City of Emeryville

MEMORANDUM

SUBJECT: **Ordinance Of The City Council Of The City Of Emeryville Adopting An Amendment To The Sherwin Williams Planned Unit Development/ Preliminary Development Plan (PUD/PDP) To Allow The Removal Of Street Trees On The West Side Of Horton Street (CEQA Determination: Environmental Impact Report for Sherwin Williams Project PUD Certified By City Council on September 6, 2016)**

ALTERNATIVE A
 3 TREES REMOVED (WEST SIDE)
 5 TREES REMOVED (EAST SIDE)

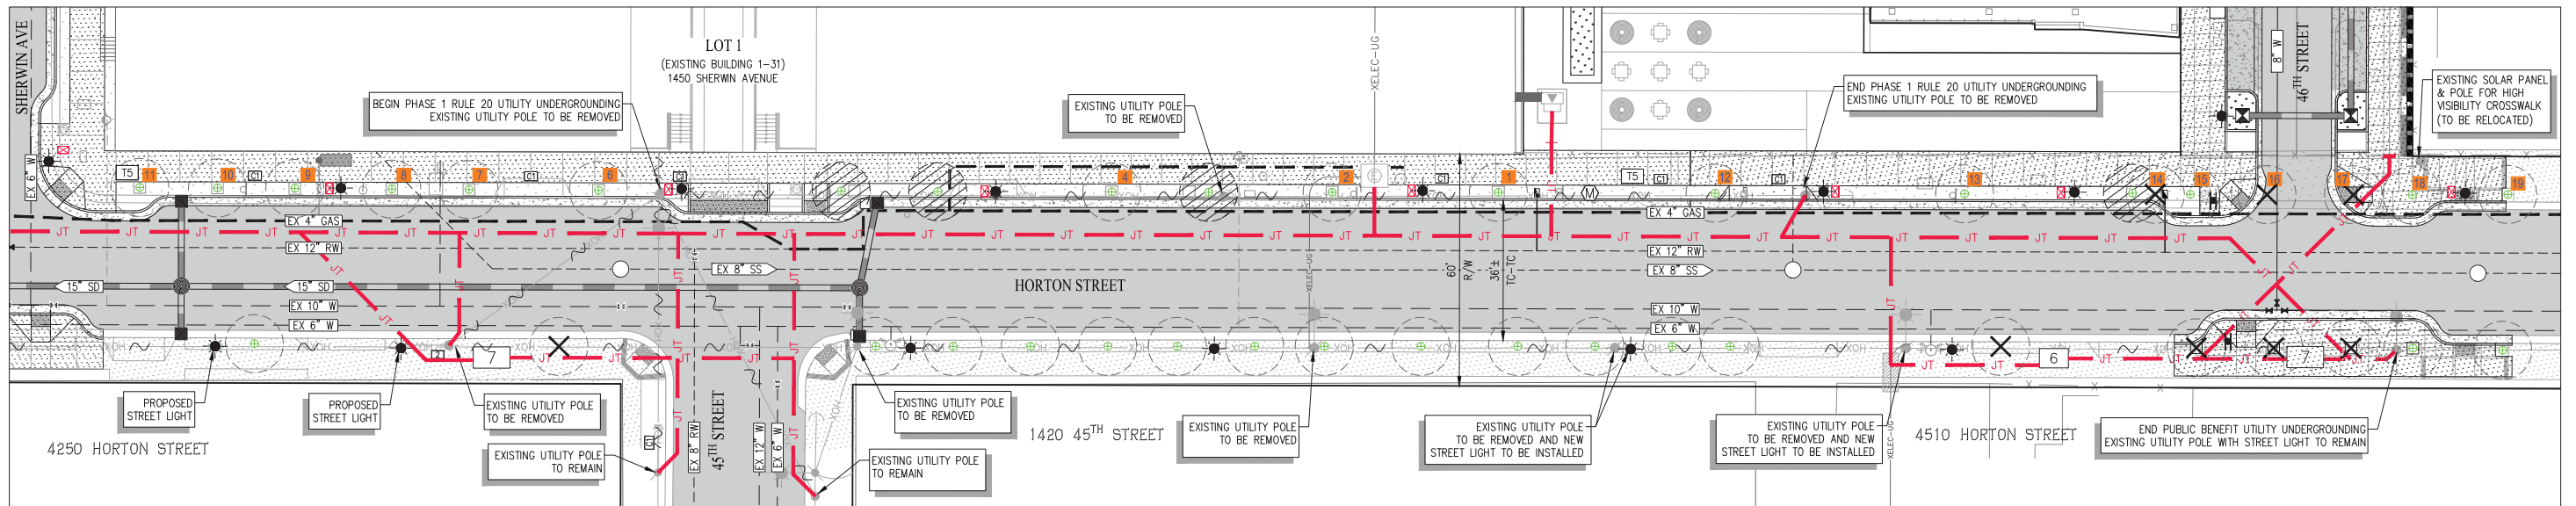
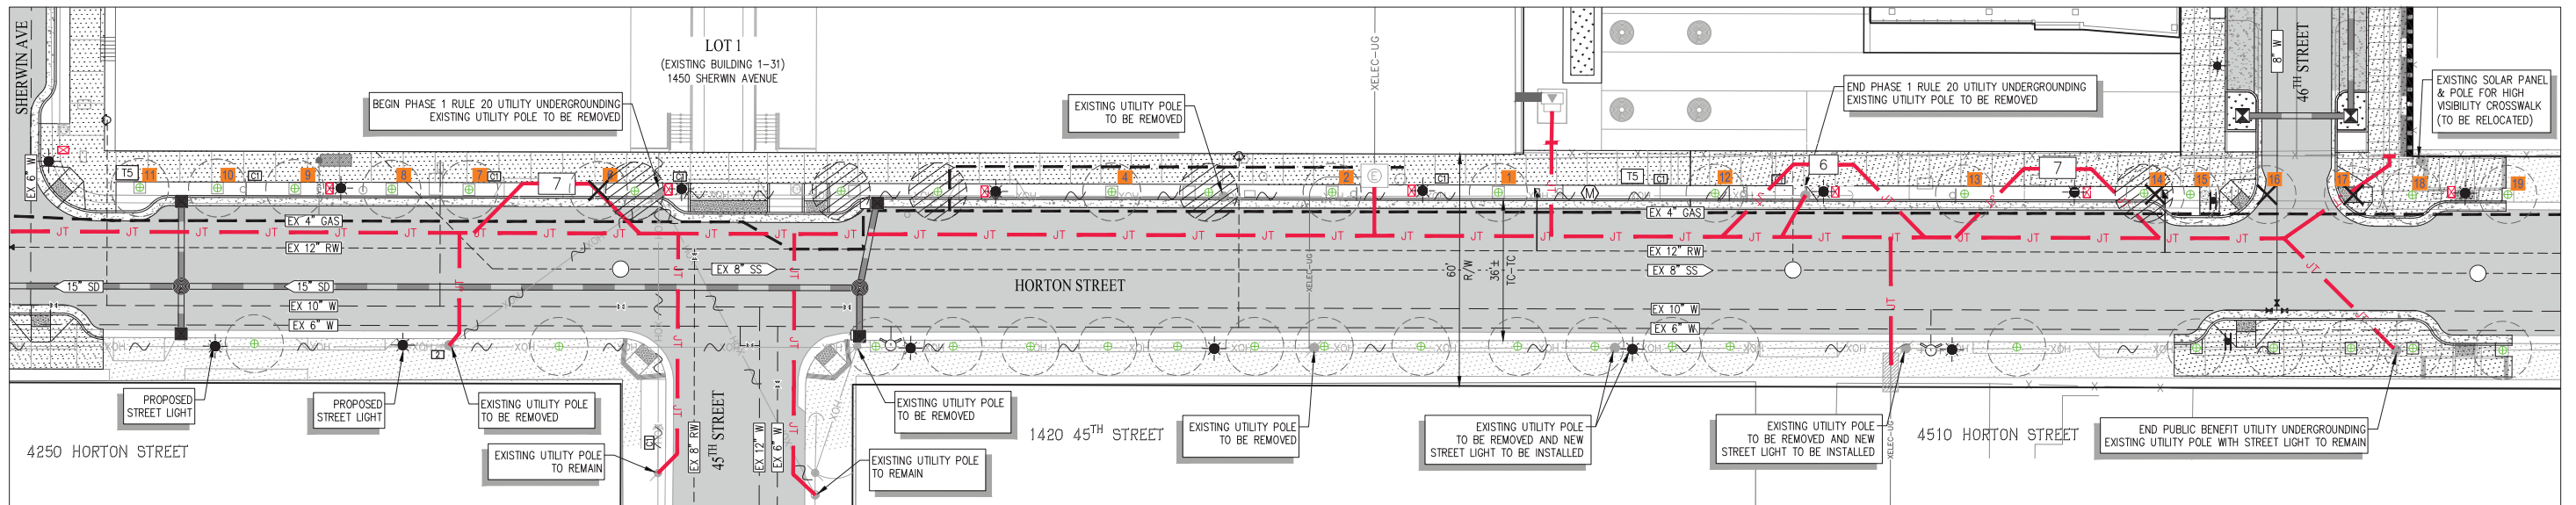
As a result of this new information, the team developed two alternatives, both of which would locate the joint trench in the street: Alternative A locates the vaults under the east sidewalk and Alternative B locates the vaults under the west sidewalk. (See Attachment 4: Conceptual Horton Street Utility Undergrounding.)

Both alternatives would result in the removal of two trees on the west side of Horton Street at the north end of the project site, identified as #16 and #17 in the November 15, 2018 arborist report (Attachment 3c). These trees need to be removed because they are in the intersection of the new 46th Street, not because of the undergrounding. Both alternatives also identify tree #14 on the west side of Horton Street for removal because it is dead; however, this tree has already been removed by the City after these alternative drawings were prepared. It should be noted that none of these three trees was shown as an "existing tree" on the Landscape Plan included in the approved PUD/PDP, so it was already assumed that they would be removed. (Trees #3 and #5 were previously removed by the City; the November 15, 2018 arborist report notes that there is "no tree" in these locations.)

Alternative A would result in the removal of five additional trees on the east side of Horton Street, identified as #12, #13, #14, #15, and #29 in the March 5, 2018 arborist report Attachment 3b). That arborist report provides the following information about these five trees:

Alternative B would result in the removal of one additional tree on the west side of Horton Street, identified as #6 in the March 5, 2018 arborist report. This is an 8" diameter *Sophora japonica* (Japanese Pagoda) valued at \$2,018.

Alternative B has been selected as the option to pursue because it results in the least number of trees to be removed, and has no impact on the relatively new sidewalk on the east side of Horton Street.
